Stage 4: Code Administrator Consultation	At what stage is this document in the process?
-------------------------------------------------	------------------------------------------------

GC0096

Modification Title: Energy Storage

Figure 2.0

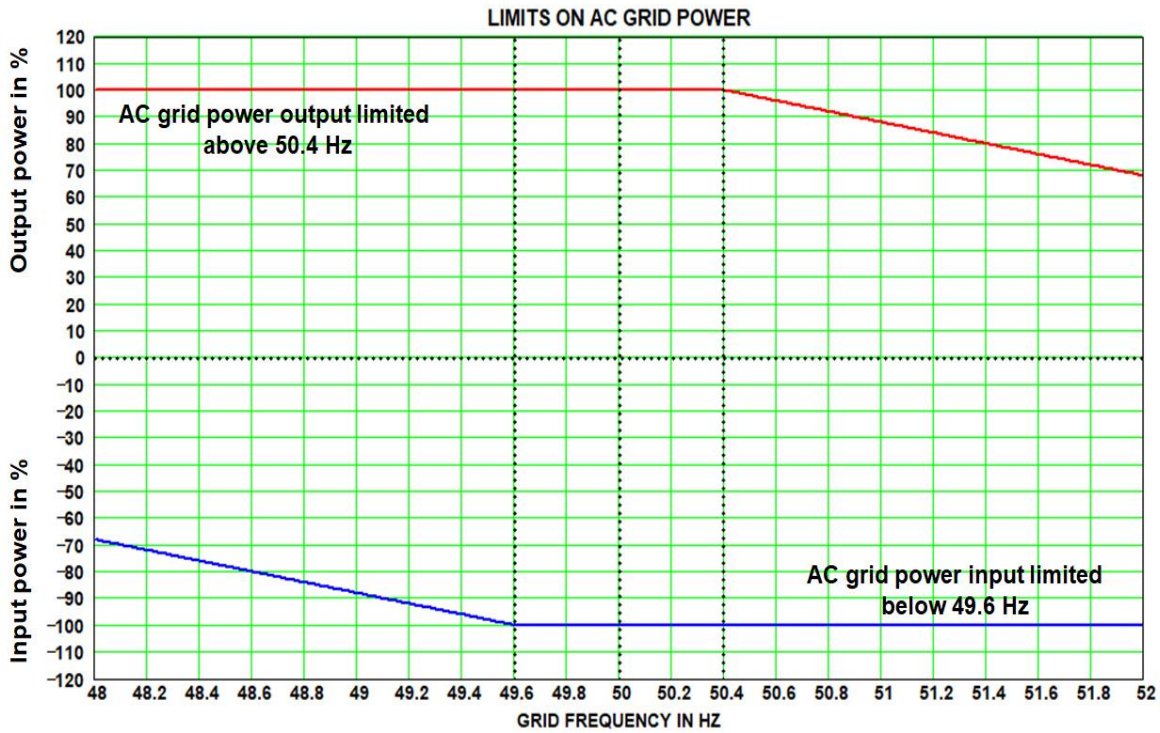
As part of the Workgroup discussions, one Workgroup member noted that storage should have a requirement to cater for limiting power input with falling frequency and limiting power output with rising frequency and proposed the use of the following graph.

The Proposer would however note that the characteristic shown in Figure 2.0 may be more appropriate however as also pointed out by a workgroup member this requirement applies to generation equally as it applies to Storage. As such, and as the aim of the workgroup is to ensure consistent treatment between different classes of User's, this is an issue that should be highlighted as a future area of work as the implications of a change to generation affects a much greater audience.

Figure 3.0 (a)

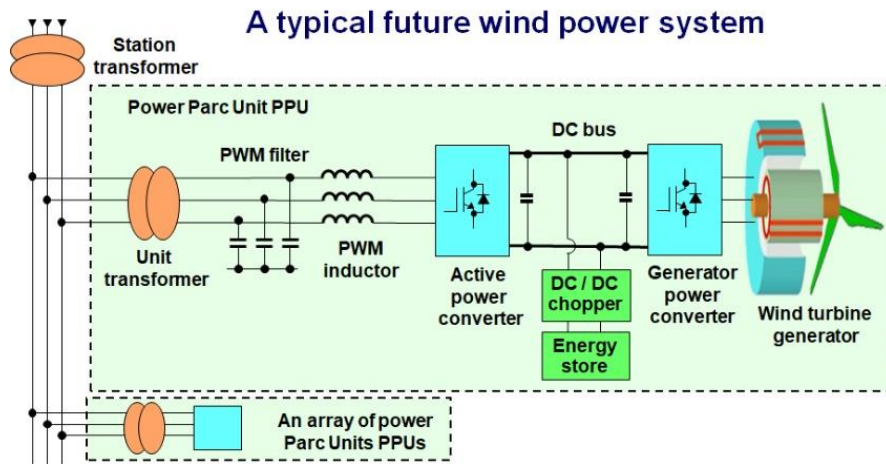
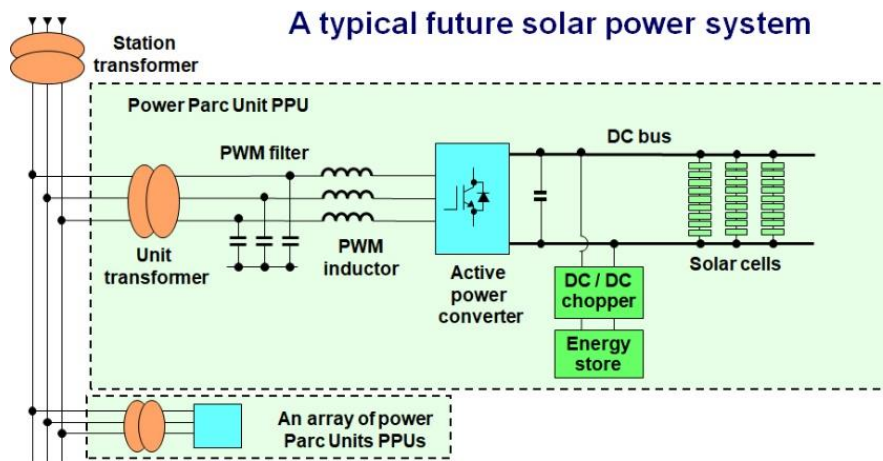
In addition, a Workgroup Member noted that as part of a future co-located site that it was entirely likely that an energy storage technology could be integrated as part of a solar park, wind farm or synchronous plant. Figure 3.0(a) and Figure 3.0(b) below (which have been re-produced in this report with the kind permission of ENTSO-E) illustrate this example for a wind farm or solar park.

One Workgroup member noted that for wind farms and solar parks, the storage elements are not directly connected to the AC system and raised concern that they would not be required to satisfy the requirements of the GC0096 proposals. It was also noted that for rotating synchronous generators this is not so much of an issue.

In response, the Proposer would note that where you have a Power Station comprising of Power Park Modules and/or Electricity Storage Modules, the Grid Code applies to the Power Park Modules and Electricity Storage Modules within that Power Station.

In addition, the Proposer would note that as part of the GC0096 proposals, that when a storage element is operating in a condition analogous to demand, then there is a requirement for this demand to be reduced as frequency falls as defined under OC6.6, in just the same way as pump tripping as part of a pumped storage plant.
